Re: Written *Ex Parte* Notice, GN Docket No. 14-177, IB Docket Nos. 15-256 and 97-95; RM-11664; and WT Docket No. 10-112

The Boeing Company (“Boeing”), through its counsel, hereby responds to certain of the reply comments that were filed on October 31, 2016 regarding the ability of non-geostationary satellite orbit (“NGSO”) systems to operate in the 37.5-40.0 (“37/39”) GHz band using power levels that may reach up to the power flux density (“PFD”) limits maintained by the International Telecommunication Union (“ITU”)¹ and maintained by the Commission in Section 25.208(r)(2) of its rules,² without resulting in harmful interference to existing or future terrestrial services.

Figure 1 – Corrected Sidelobes for Straight Path Antenna Model (Original and Corrected Shown)

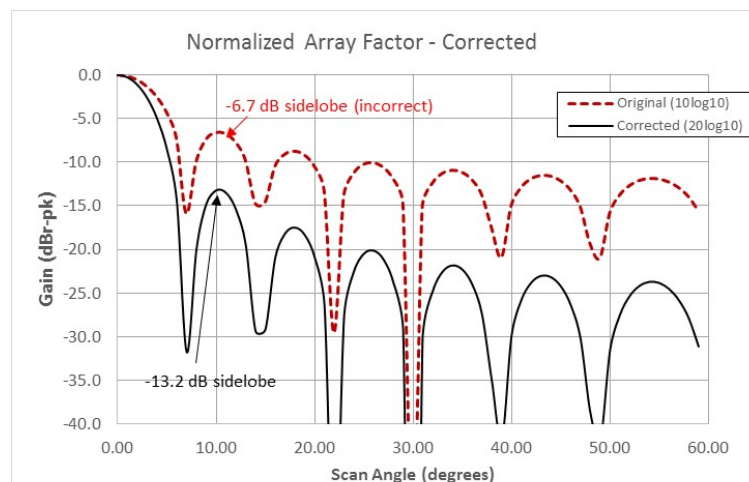
As noted above, the most significant error in Straight Path's analyses is the use of an incorrect equation for the model of the UMFUS planar array antenna.⁹ A complete explanation of the errors in the Straight Path antenna model is provided in Part 3 of the Attachment to this letter. Once the antenna model is corrected, the antenna pattern (shown below in Figure 1) exhibits the predictable textbook behavior with first sidelobe levels of -13 dB,¹⁰ whereas the erroneous Straight Path equation results in sidelobes that are twice as high (e.g., -6 dB relative to peak versus -13 dB). This foundational error significantly alters all of Straight Path's findings.

Figure 2 – Rise in Base Station Noise Floor (Straight Path Figure 10)

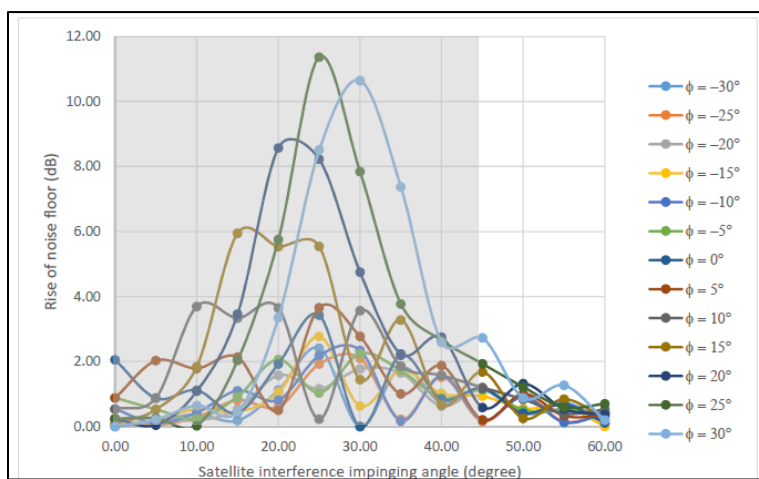
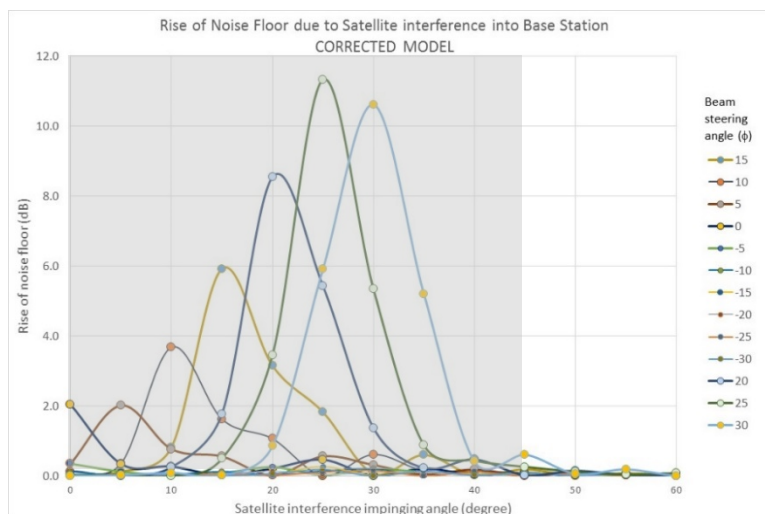
Figure 2 below illustrates Straight Path's original Figure 10 from its reply comments showing the predicted rise in noise floor for a 16x16 base station using an incorrect antenna model.¹¹ Figure 3 below then provides the same analysis with the calculations in the antenna model corrected.

Importantly, Figures 2 and 3 above have *not* been corrected with respect to any of Straight Path's erroneous assumptions regarding the operations of Boeing's NGSO satellite systems (*i.e.*, NGSO satellite movement, the use of high elevation angles, and the use of power control). Figures 2 and 3 continue to assume that satellite transmissions will arrive at very low elevation angles from fixed points in the sky and with no power control, which is not the case with Boeing's NGSO system. Nevertheless, the figures above are helpful particularly in showing the tremendous reduction in interference levels as the satellites exceed an angle of incidence of around 40 degrees.

Figure 4 – Rise in Base Station Noise Floor Due to a Single Boeing NGSO Satellite in Rain Fade

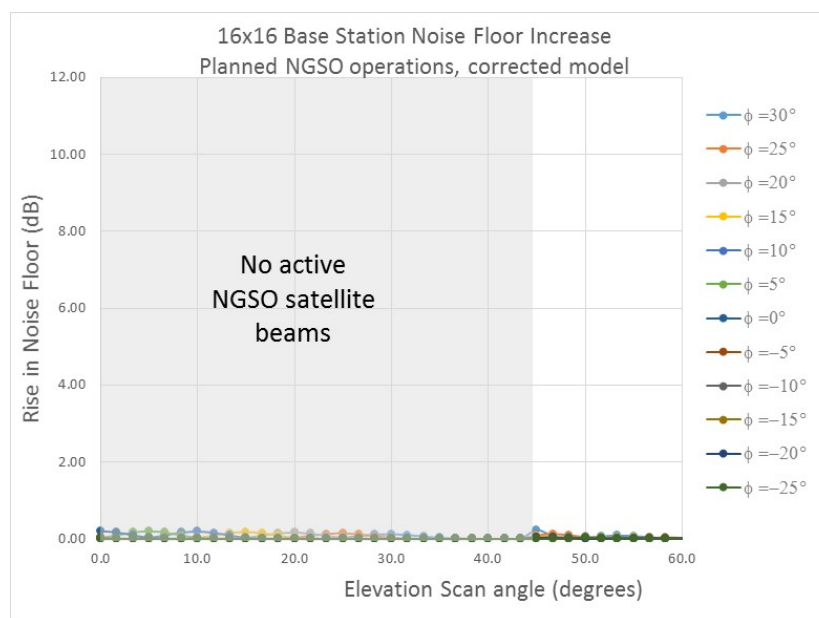
To correct for these errors, Boeing again employs Straight Path's analysis from above involving the noise resulting from a single satellite into an UMFUS base station, but applies Boeing's planned operating conditions of NGSO satellites transmitting only from an elevation angle of above 45 degrees and using power control levels appropriate for worst-case rain fade conditions. The resulting increase in the noise floor from the transmissions of a single satellite at elevation angles above 45 degrees is less than 0.25 dB.

These corrected results are well within the manageable degradation levels referred to by Straight Path and are fully consistent with Boeing's prior ePFD results, which show noise floor degradations of less than 0.65 dB resulting from Boeing's entire constellation. The aggregate ePFD levels from the entire constellation of Boeing's NGSO satellites are provided below in Table 1. The interference scenario involving an UMFUS base station was captioned as Case 3a in Boeing's Further Notice comments and clearly shows a 0.65 dB increase in the noise floor for 99.5 percent of all possible beam steering cases from the base station, and only during infrequent high-rain fade events.¹⁵

Figure 5 – Potential Degradation to UMFUS Device With Multiple Array Antennas

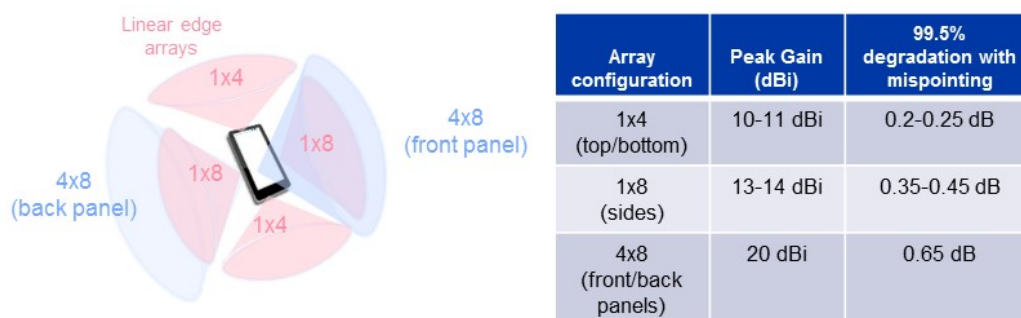
In its Further Notice Reply comments, T-Mobile does not dispute that an ePFD approach is appropriate for interference calculations involving multiple NGSO satellites, but T-Mobile questions some of Boeing’s assumptions regarding mobile user handset antennas for UMFUS devices.²³ In particular, T-Mobile is concerned that an UMFUS device with multiple small antenna arrays on different sides and edges of the device may experience increased interference from satellite downlink transmissions, in part because the additional antennas may increase the total number of satellites within the field of view of the device.²⁴

Second, Boeing's ePFD analysis already assumed that the antenna array on the mobile UMFUS device would be pointing directly at a satellite, rather than at its intended base station. As a result, any other orientation of the UMFUS antenna array could only reduce the potential for interference, rather than increase it. To this end, Figure 5 illustrates a potential handheld UMFUS device with element arrays laid out in manner similar to that described by T-Mobile. Though there are obvious space limitations in compact handheld devices, the beams are intended to provide coverage of largely independent sectors to cover the omnidirectional (4π steradian) field of view of the device with separately steered high-gain beams. The noise floor degradation into each of the beams is independent, and are listed in Figure 5.

All of the satellites within the visible field of view (above the horizon) have already been included in these ePFD and noise floor degradation calculations – no more satellites can be seen by adding more beams from various faces of a handset device. T-Mobile's concerns that multiple beams employed by an UMFUS end user device may experience more interference is unfounded and such devices are already envisioned and included by the ePFD regulations proposed by Boeing.

Figure 3-1 – Rise in Mobile Station/Handset Noise Floor (Straight Path Figure 7)

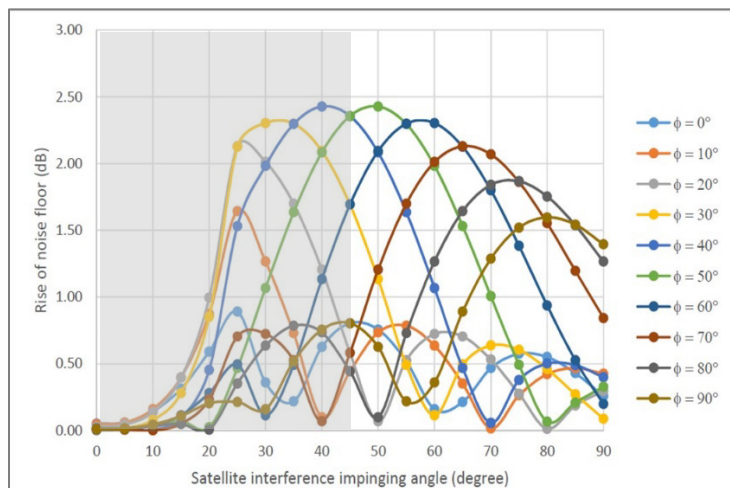
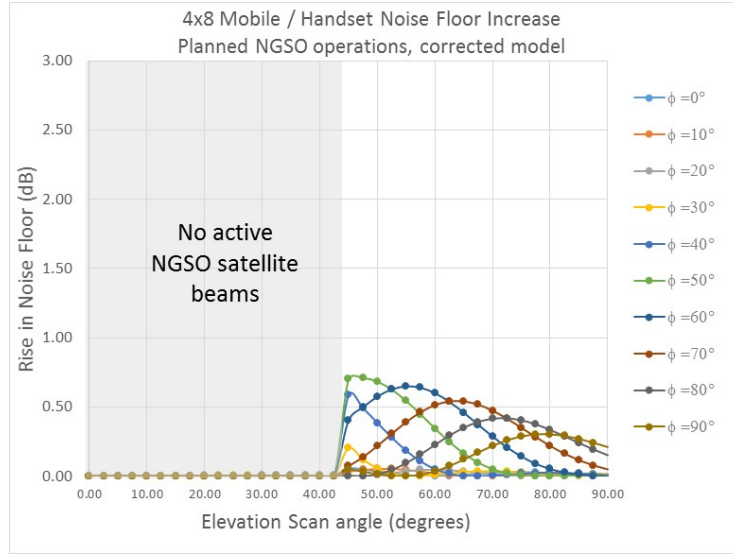
As noted in the accompanying letter, Straight Path’s October 31 analysis used an incorrect equation for the model of the UMFUS planar array antenna, along with a number of incorrect assumptions regarding the operation of Boeing’s NGSO satellites in the 37/39 GHz band. Boeing provides an analysis below using Straight Path’s methodology to show the potential impact of Boeing’s NGSO system to an UMFUS mobile device with the errors and assumptions corrected. Figure 3-1 below depicts Straight Path’s Figure 7 from its October 31 reply comments without any corrections.⁵

Figure 3-2 below then depicts this same analysis but with the antenna model corrected and employing appropriate assumptions regarding the operation of Boeing’s NGSO system including having satellites in motion and transmitting to the ground only from elevation angles above 45 degrees and using power control to increase power in response to rain fade.

The increase in the noise floor for an UMFUS mobile device resulting from the transmissions from a single satellite at elevation angles above 45 degrees is less than 0.70 dB. This compares favorably to Boeing’s ePFD results shown in Boeing’s Further Notice comments, Table V-6, showing 0.64 dB in Case 1 for mis-pointed handsets.⁶ Again, these results would only pertain for a device temporarily searching for a correct base station, for the small percentage of the time when an NGSO satellite is in the view at the peak of the antenna gain, and during worst-case rain fades (e.g., well less than 0.05% of the time).
